REQUEST FOR INFORMATION DATE: April 14, 2016 NO.: RFI-036

Project Name: Webster University Interdisciplinary Science Building Project No.: 15051

Subject: BP 1 storm clarifications

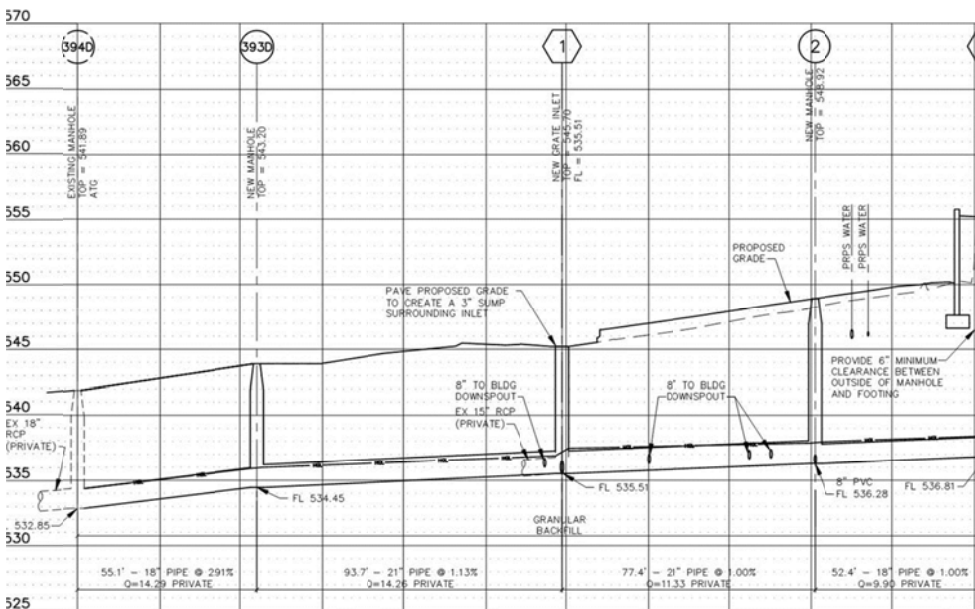
1. Assuming HGL is driving the fact that we have 21" piping upstream of 18" piping, please confirm these sizes are correct proceeding with shop drawings.
2. Please see attached email with snapshots. our existing manhole 394D correlates to manhole #11 from the EAB as-builts. The as-builts show the flow line of this manhole being 533.37, but our drawings indicate the flow line of this existing manhole is 532.85. Our design is showing that existing manhole being six inches deeper than what is shown on the as-builts.

- 1) As we look to provide a partial submittal for structures 393D, Grate Inlet #1 and associated piping, I have to ask if these pipe sizes are correct. I am guessing that HGL is driving the fact that we have 21" diameter piping upstream of 18" diameter piping. I assume that they are accounting for some surcharging in the system and the larger diameter allows for more storage. I just want to confirm this is the case, prior to us submitting drawings.
- 2) As you look at the two snapshots, our existing manhole 394D correlates to manhole #11 from the EAB as-builts. The major issue I see is that the as-builts show the flow line of this manhole being 533.37, but our drawings indicate the flow line of this existing manhole is 532.85. Our design is showing that existing manhole being six inches deeper than what is shown on the as-builts.

1. The pipe diameter has been reduced to 18".
2. The EAB was surveyed using a different datum (1929). The ISB survey datum (1988) will be used for our work.
